Siena Estates

DRAINAGE REPORT

Case Review – Siena Estates

Review comments for the Drainage Report prepared by 6K Consulting, sealed June 20, 2017 (**2nd submittal sealed August 23, 2017**). The date of our review is July 11, 2017 (**date of 2nd review is September 6, 2017**). **The Zoning Case Drainage report is approved with the following stipulations in BLUE:**

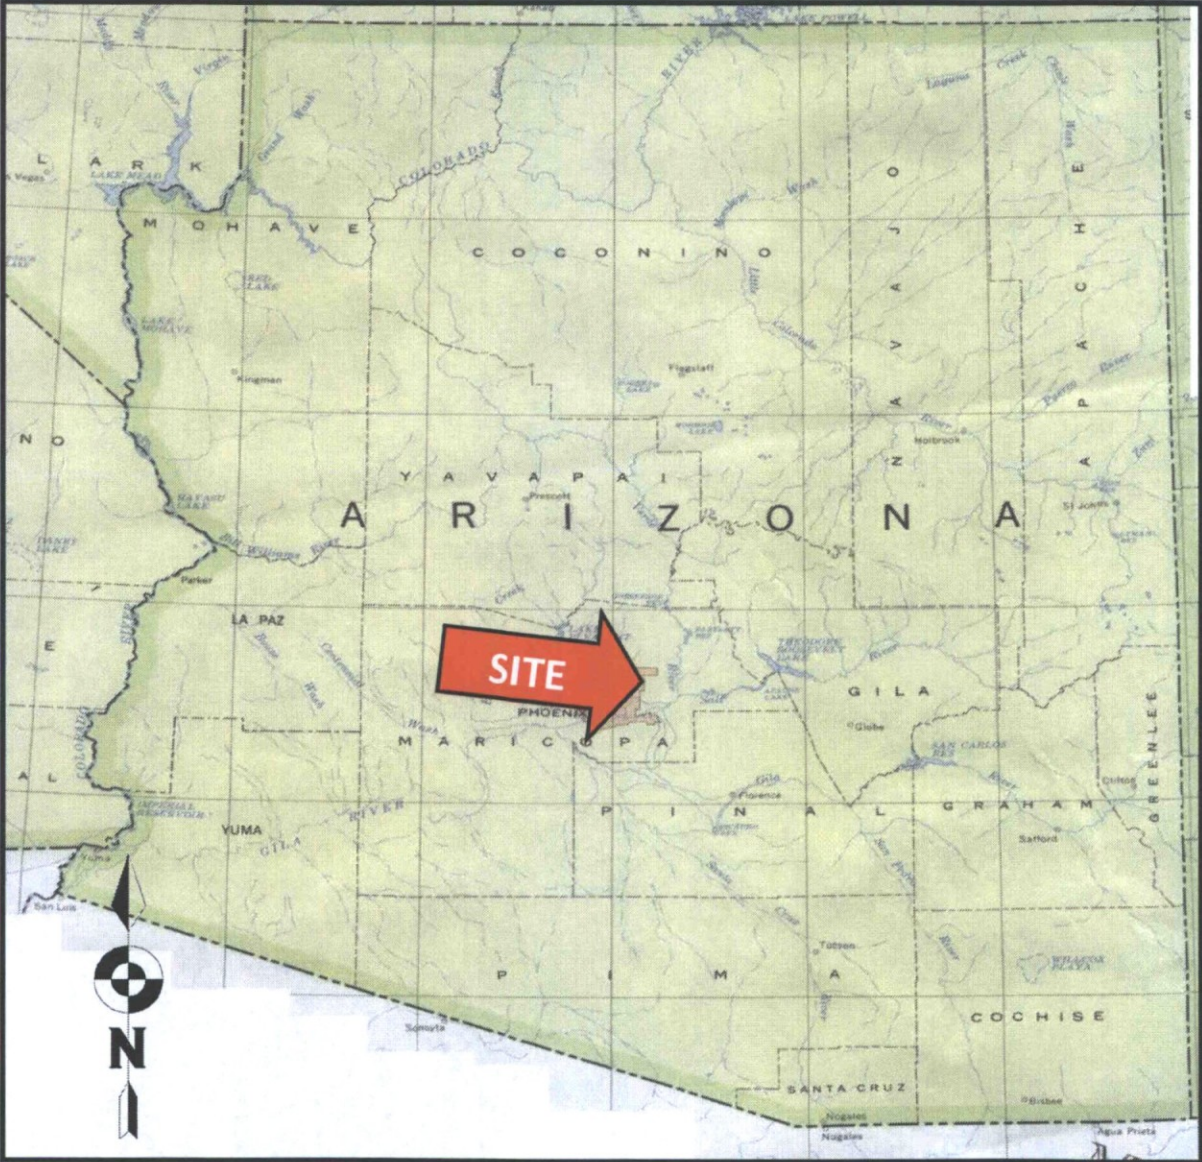
not allowed

meet pre vs post or first flush, whichever greater.

DRAINAGE MAP

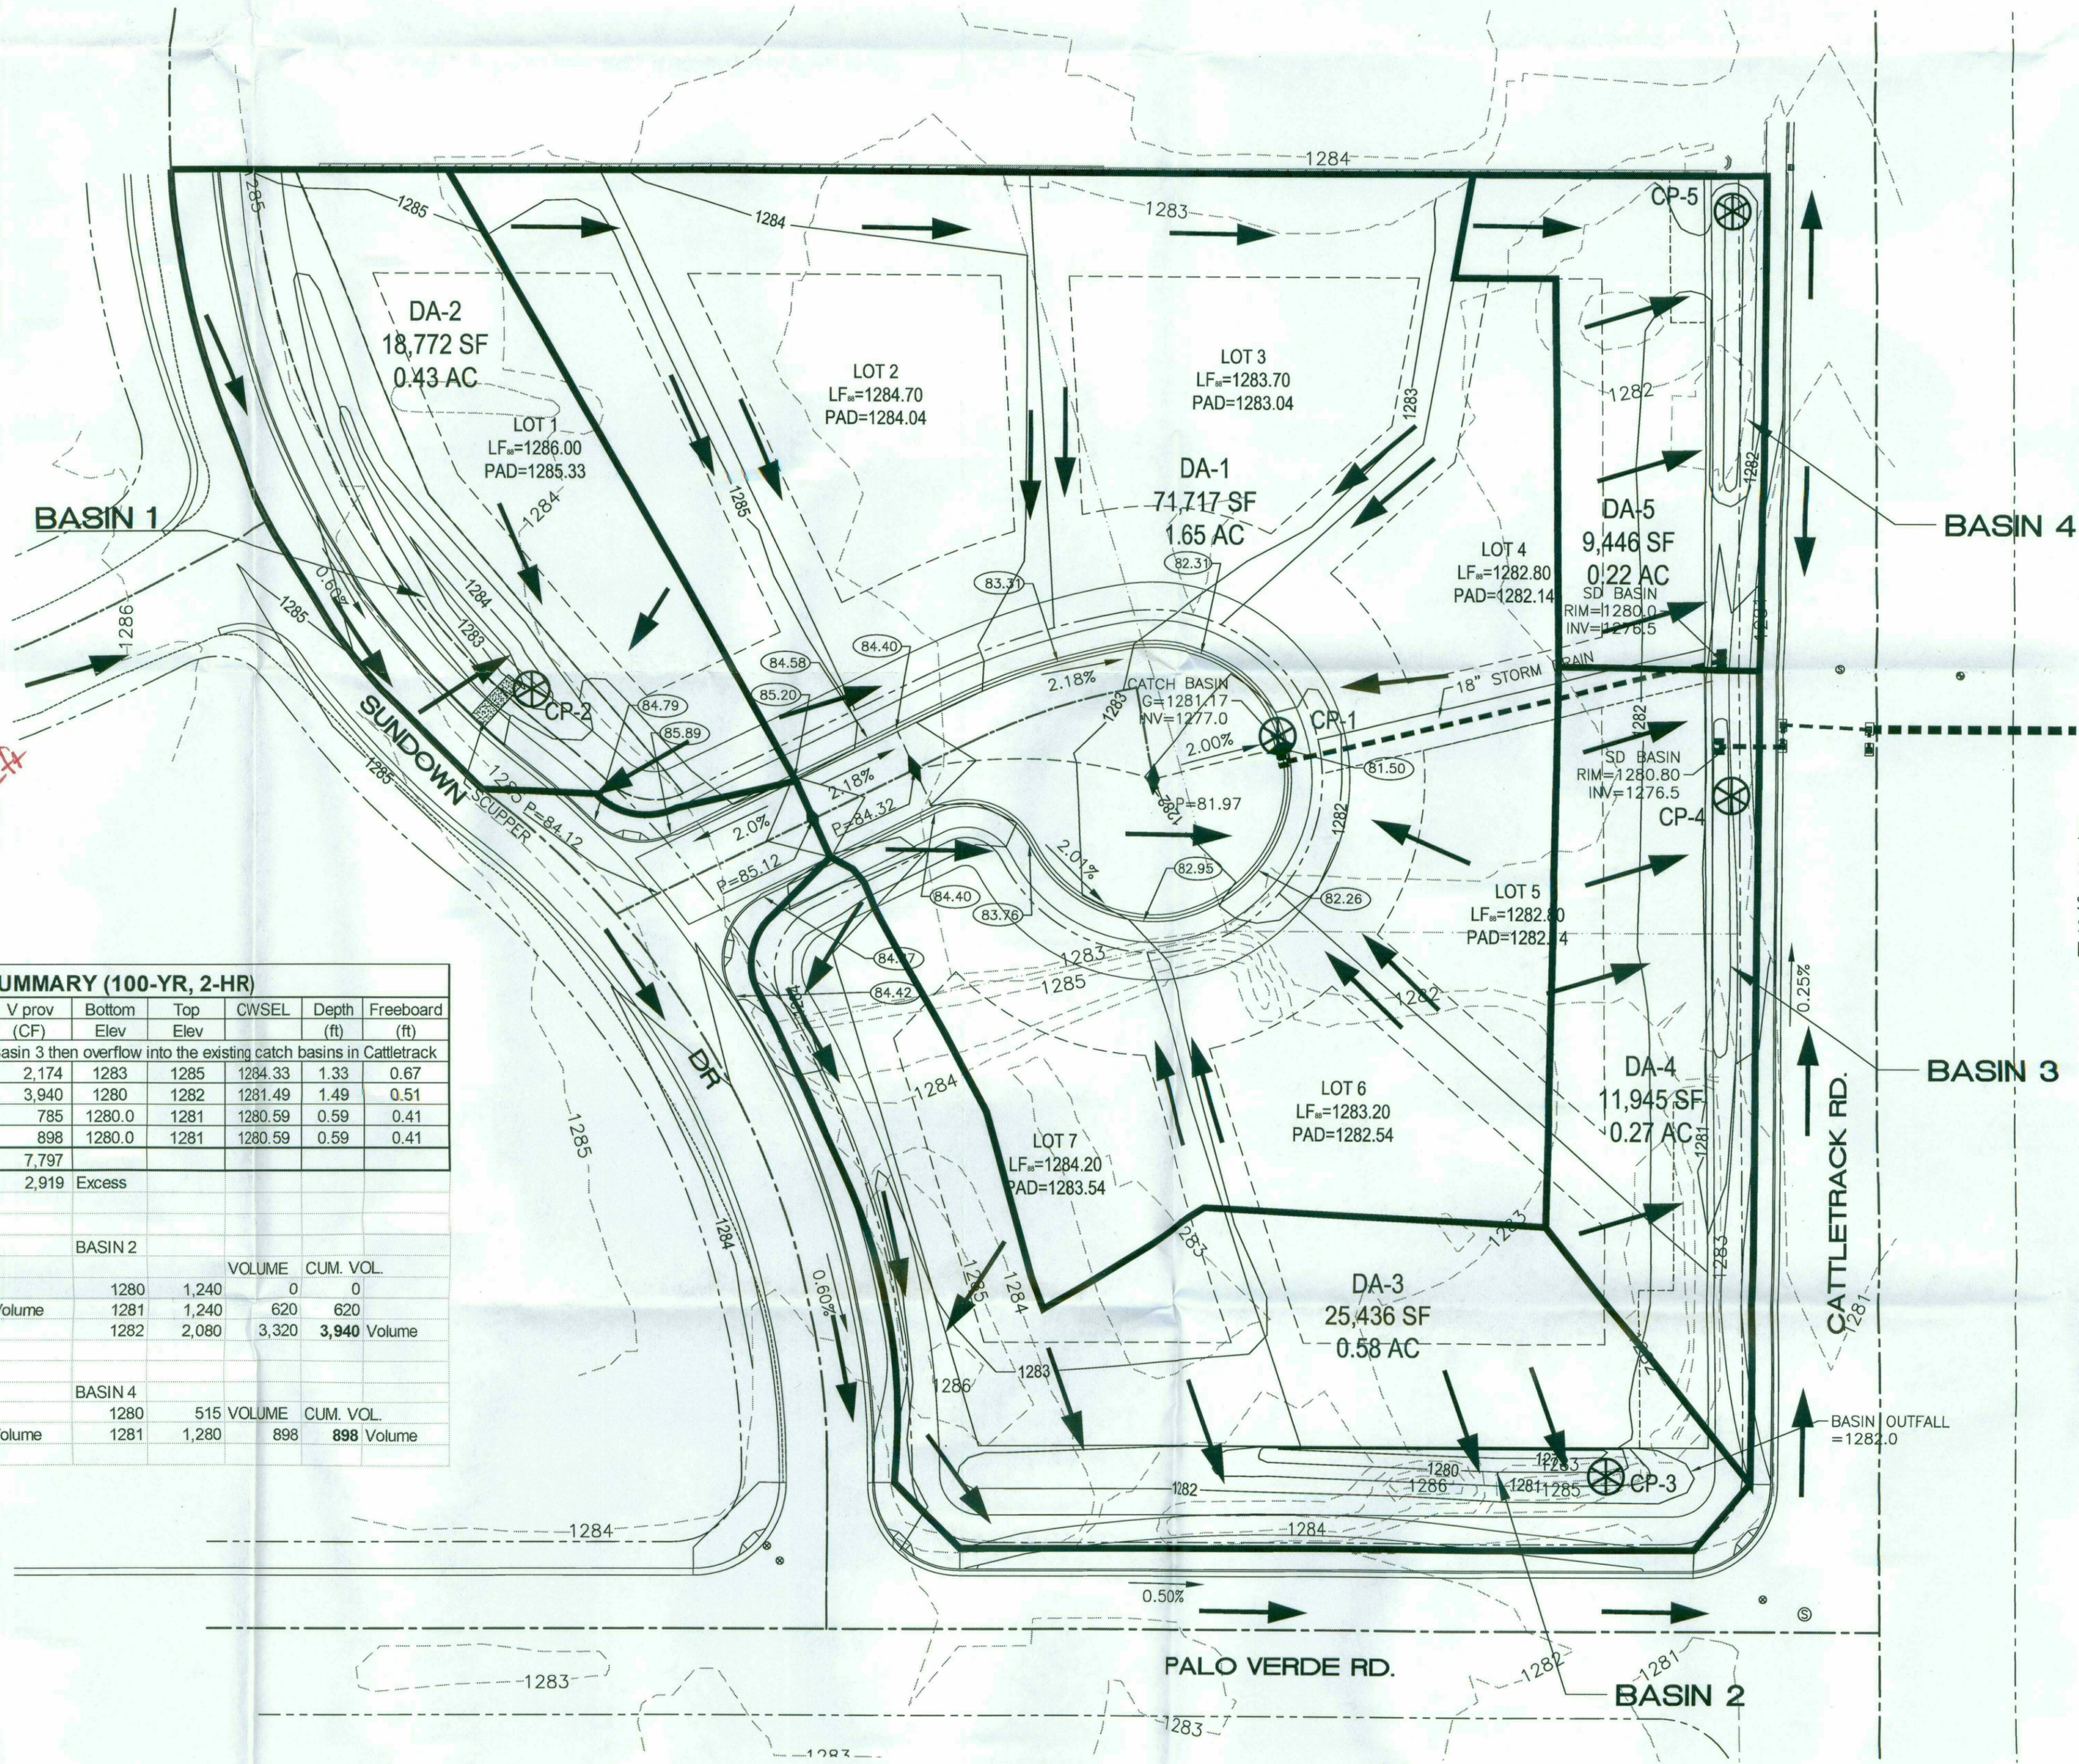
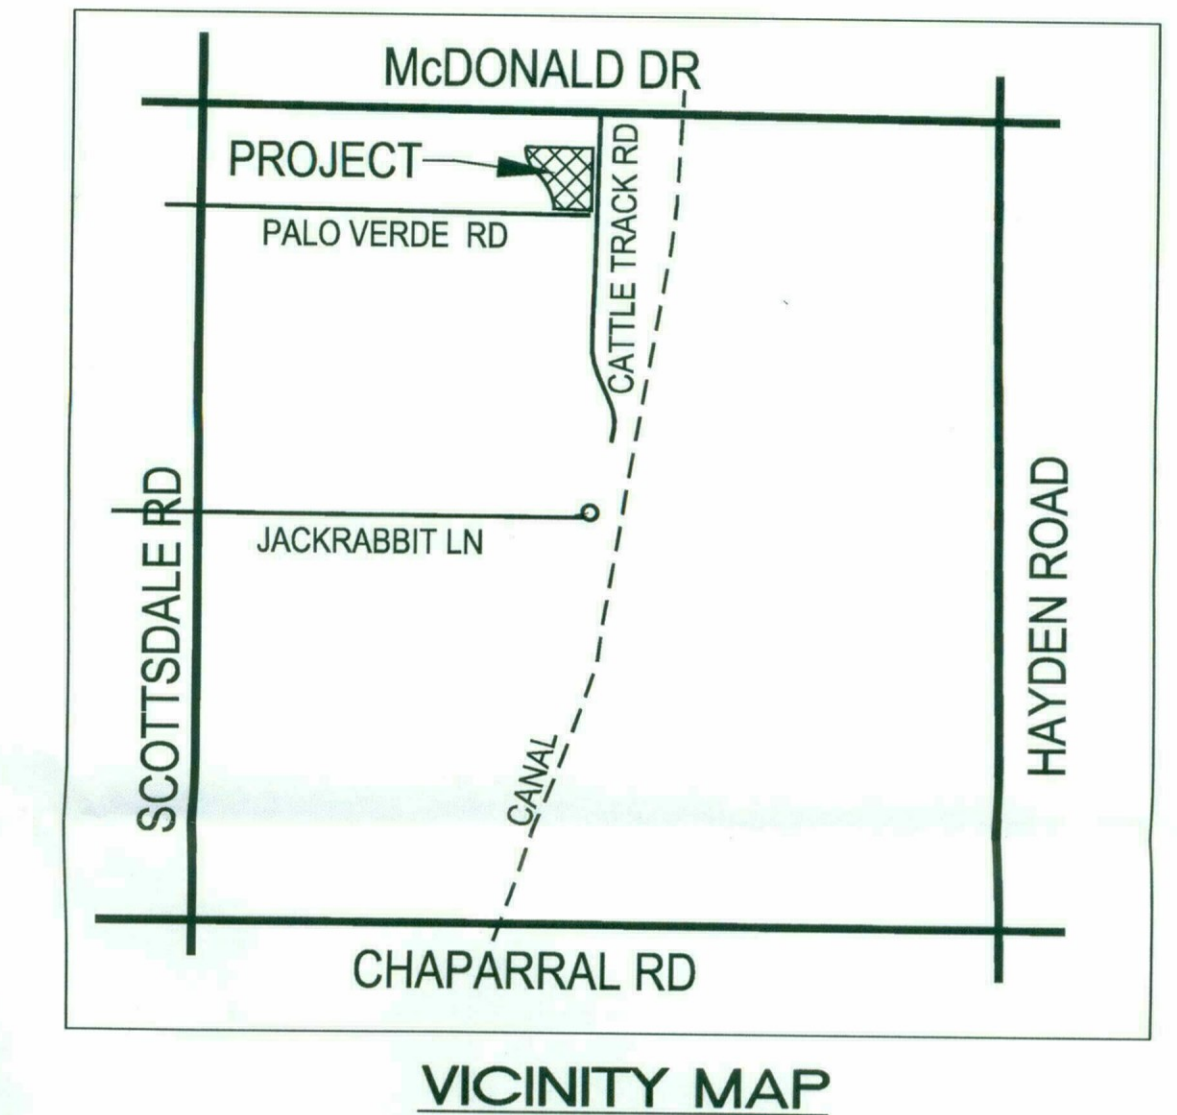
*slightly lower than rainfall from NOAA Atlas 14
2.18 in x 14
12 in = 0.182 ft*

GRADING AND DRAINAGE PLAN

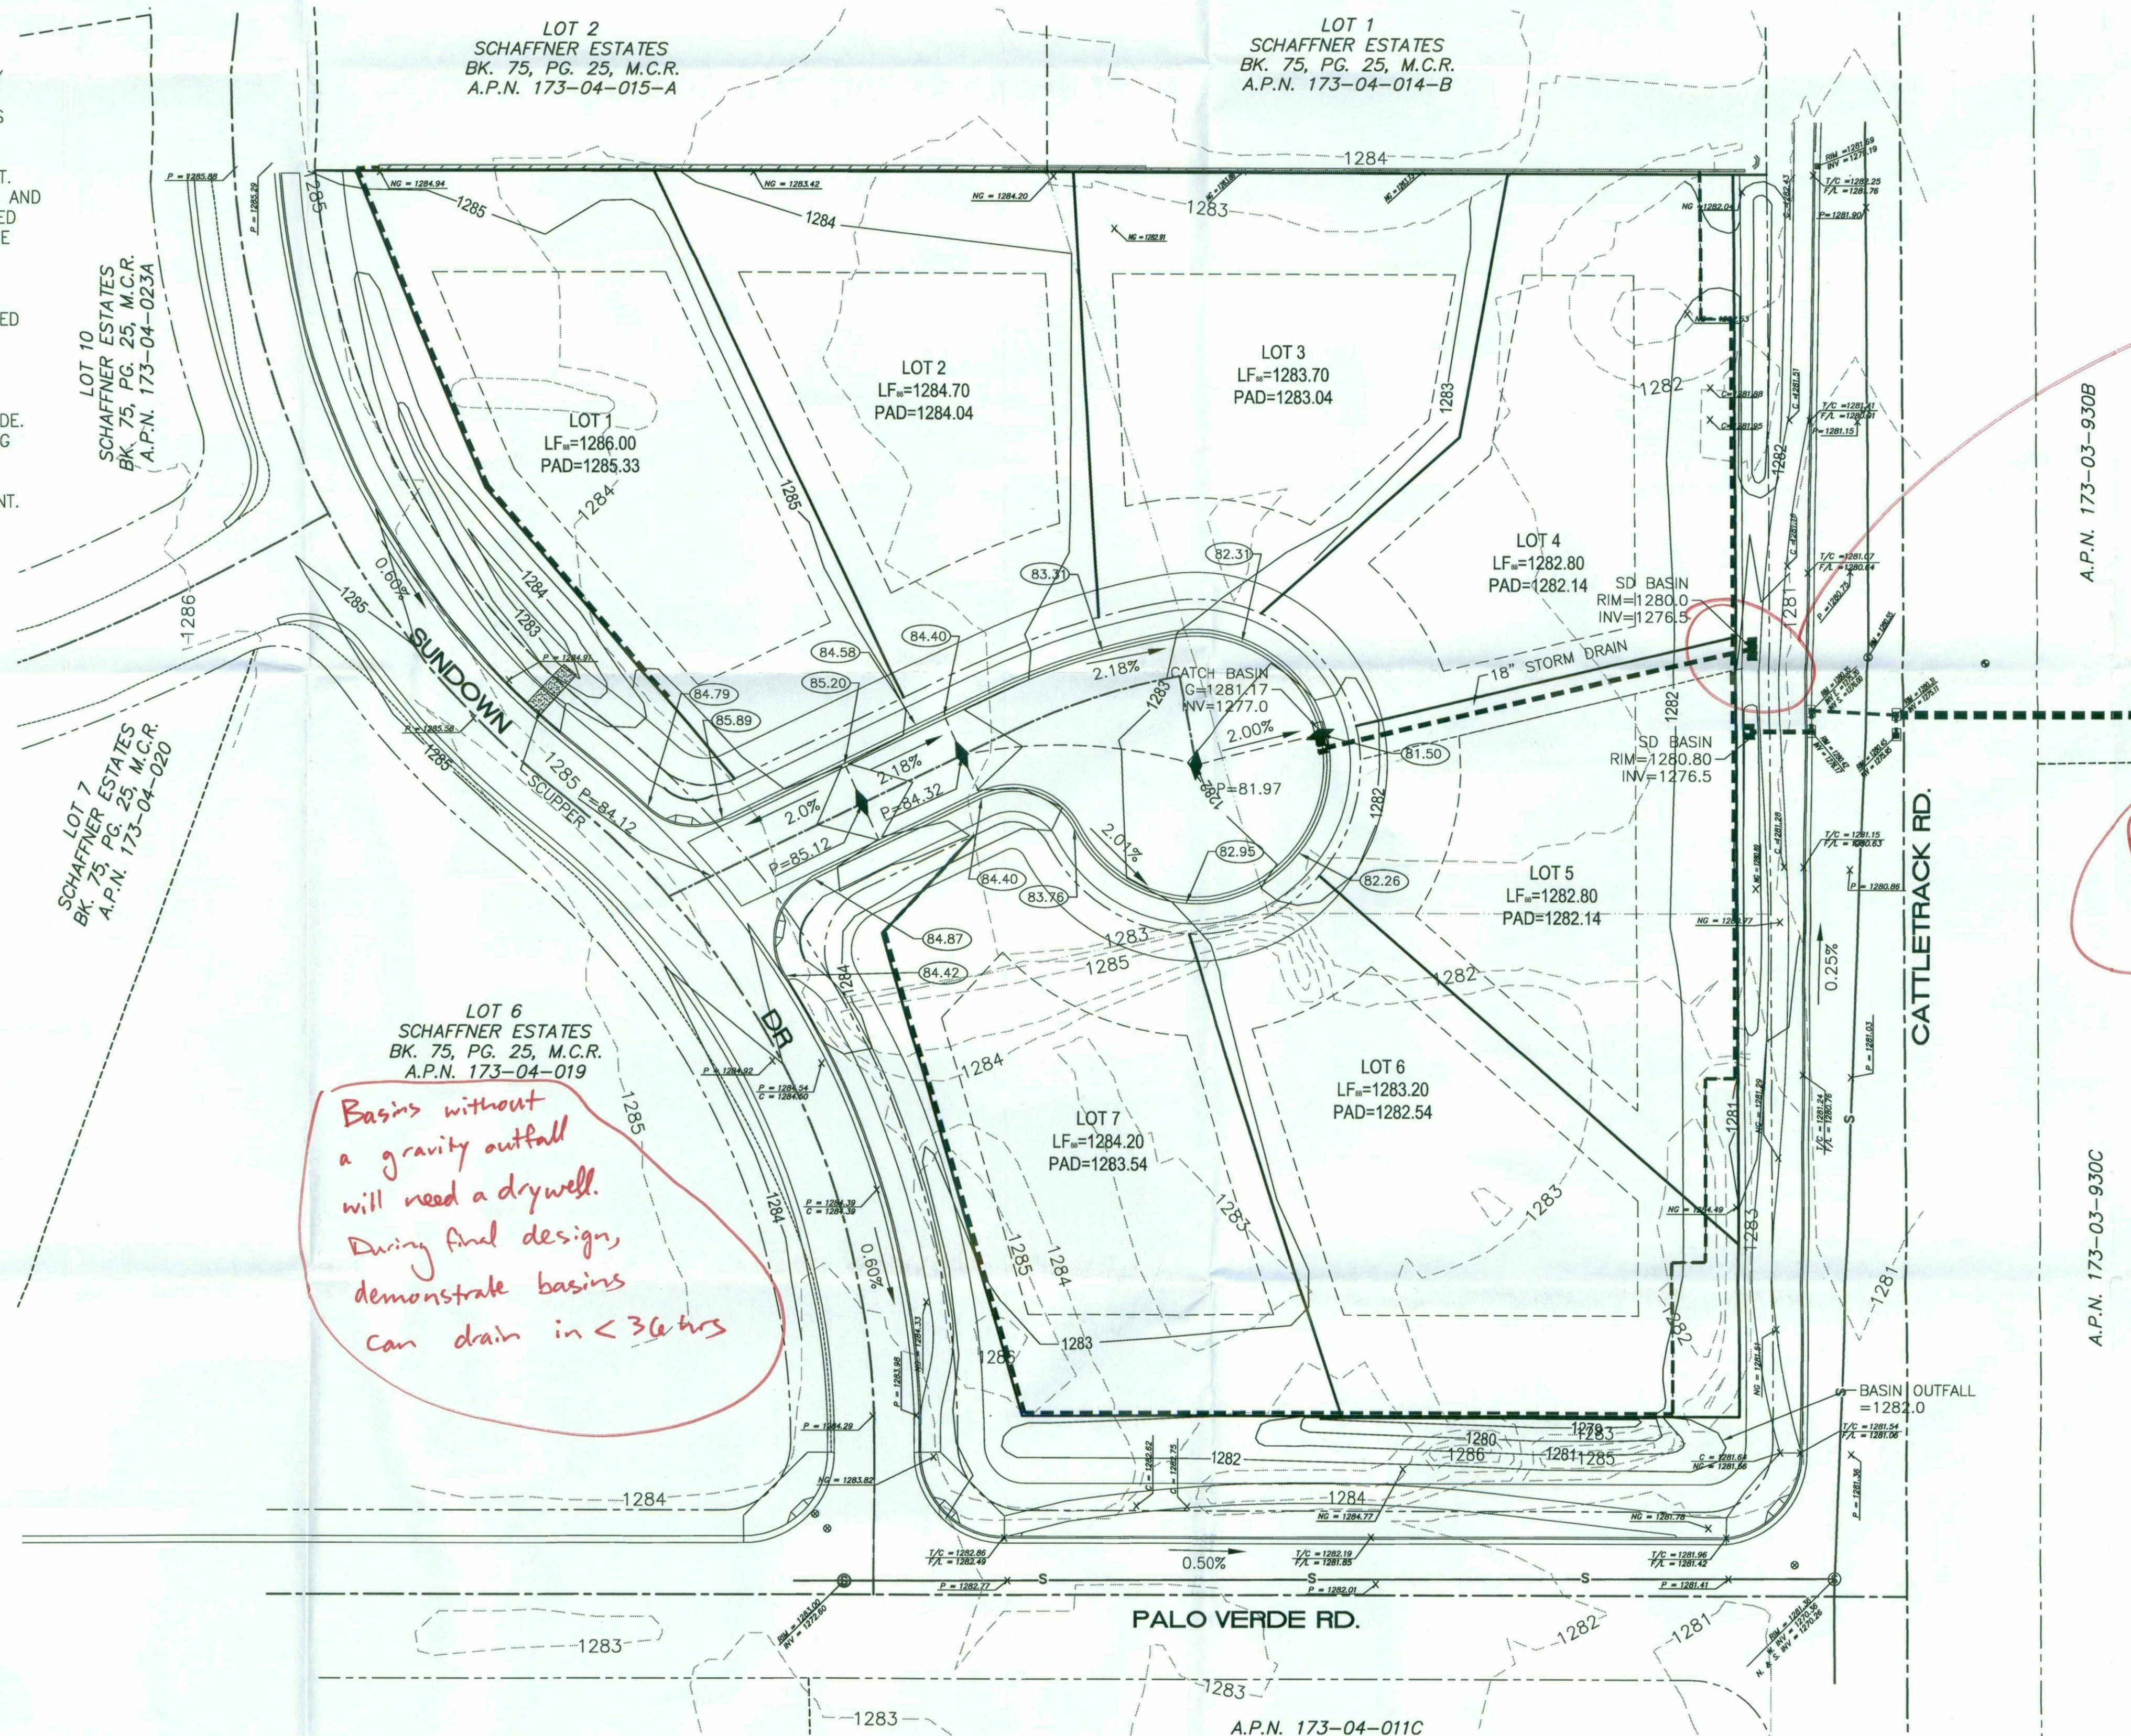
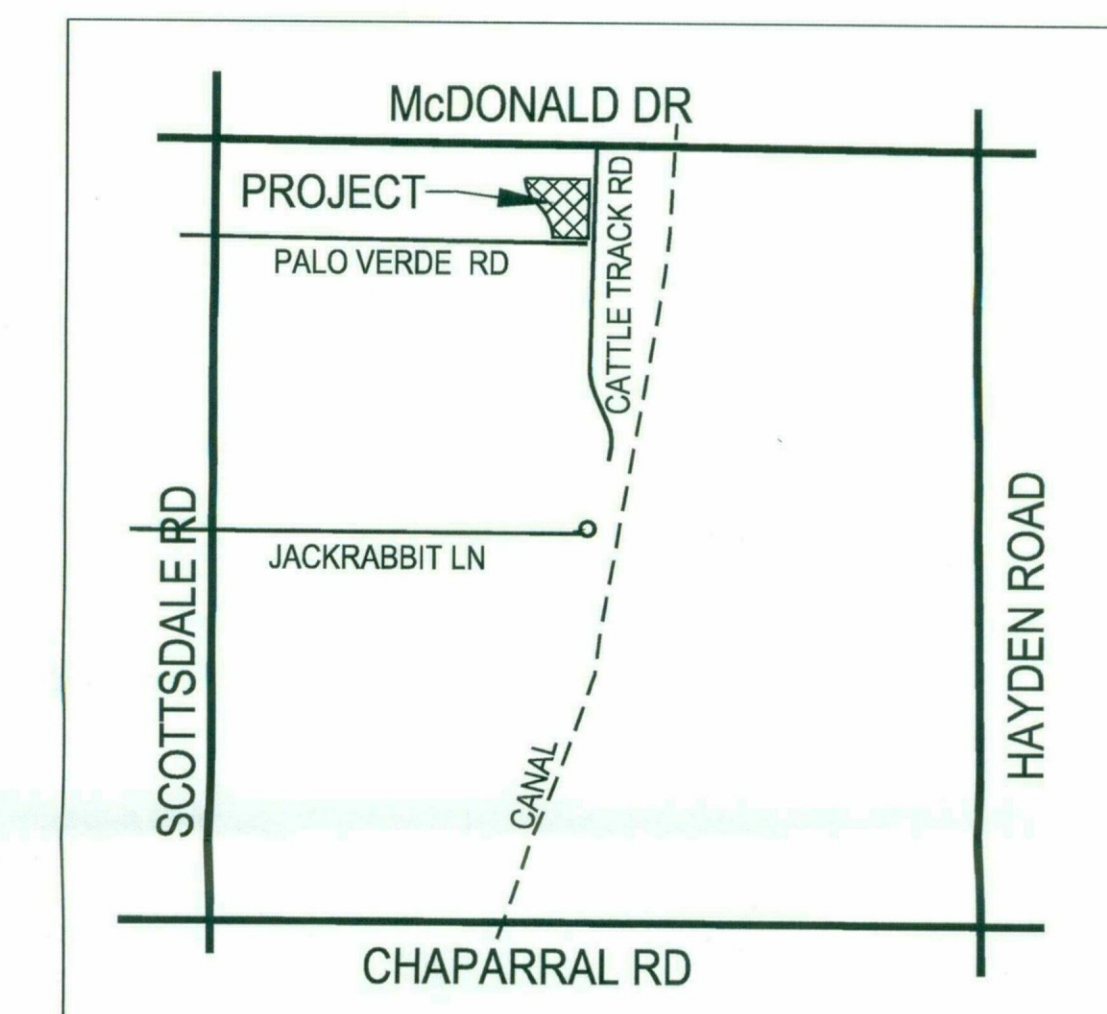
Bubbler not allowed. This has to pond up 3.5 ft before spilling over. Provide over land flow.

Provide FIRM info

Basins without a gravity outfall will need a drywell. During final design, demonstrate basins can drain in < 36 hrs
